## COMBINATION INLET

### STANDARD PLAN B-25.20-02

# SUPPLEMENTAL TO STANDARD PLAN B-25.20-02

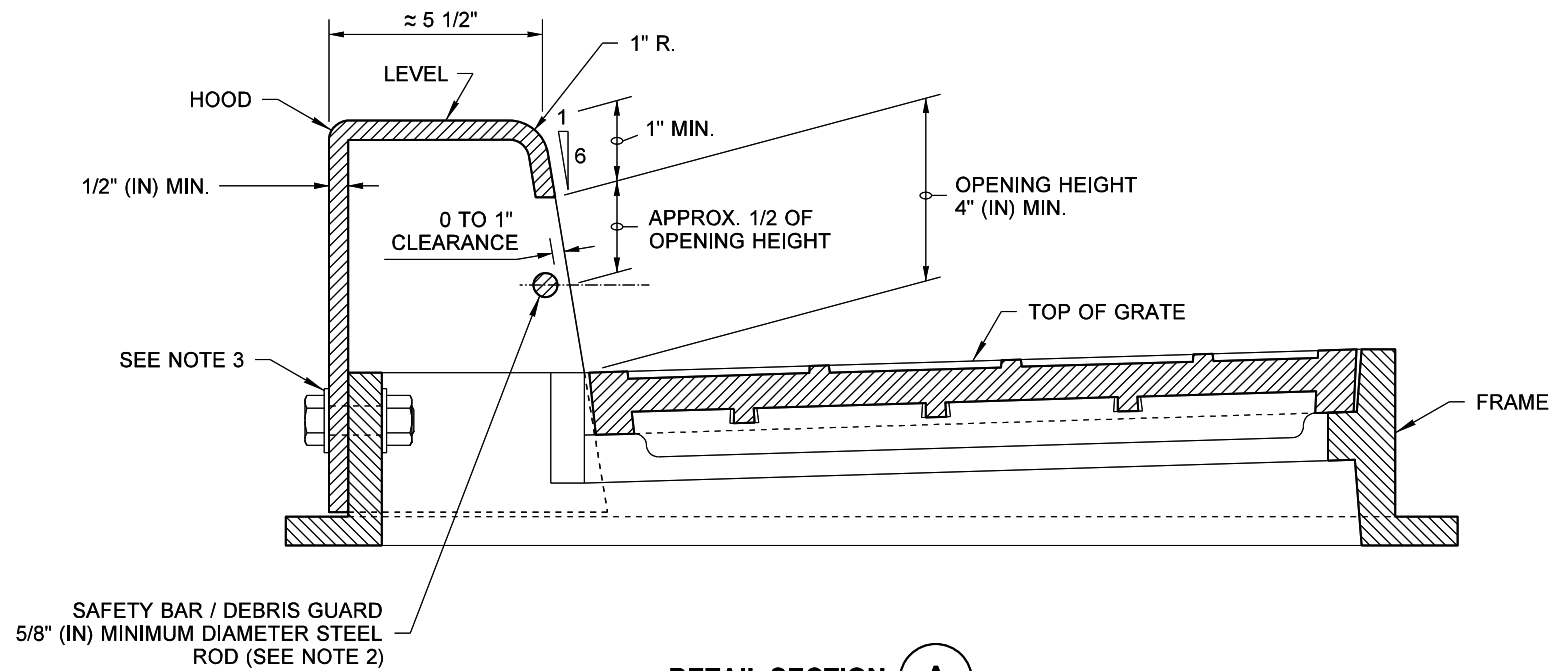
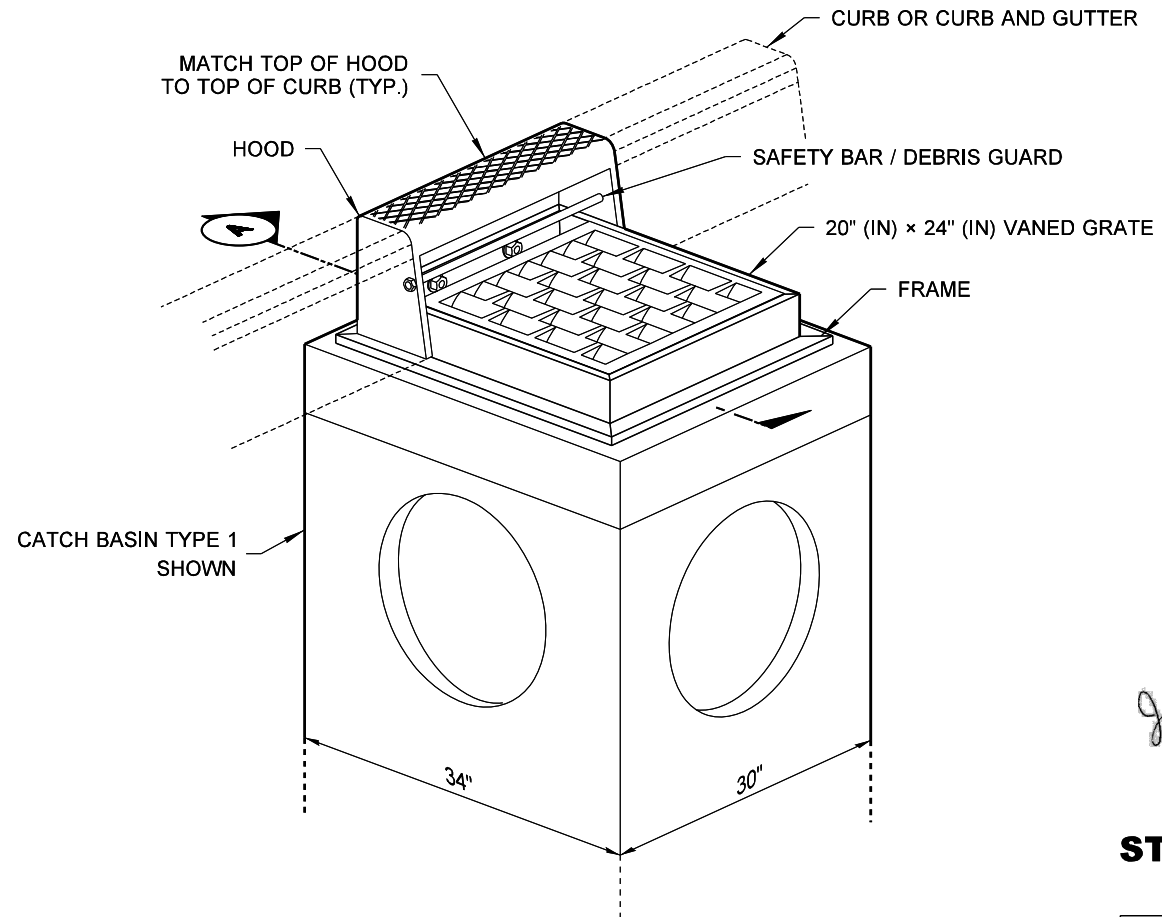
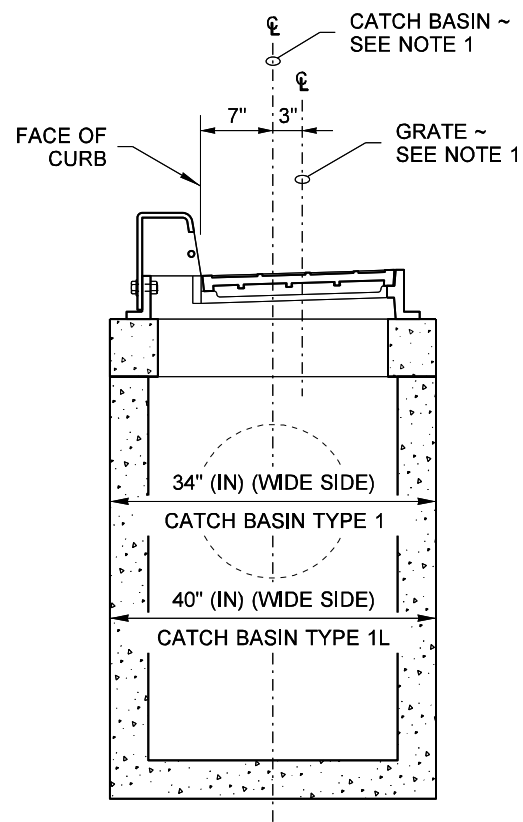
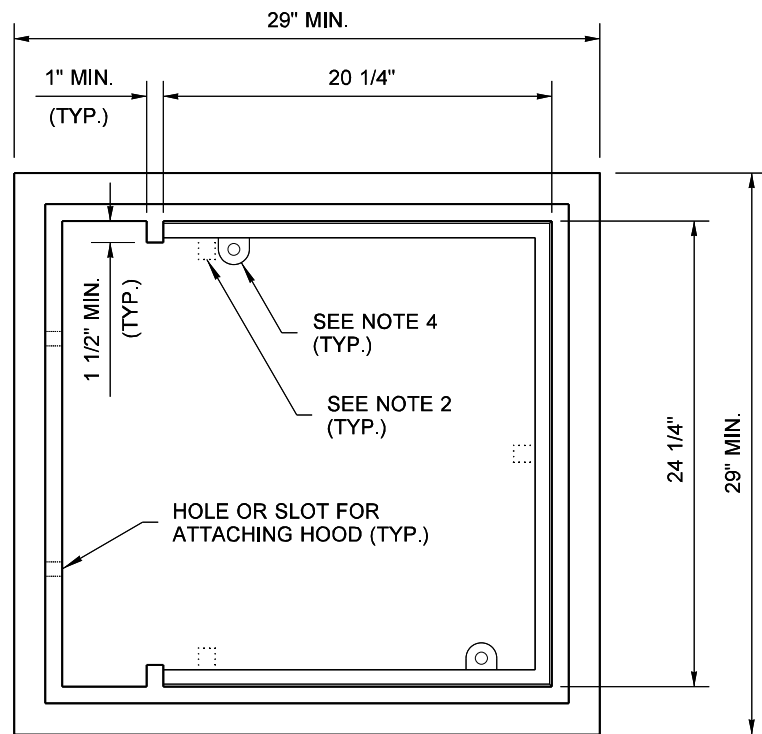
## **Modify the Standard Plan as follows:**

1. Tracer wire shall be installed along the top of all pipe entering the structure, then up the wall and attached with a 3' long coil of slack at the top inside of the structure.
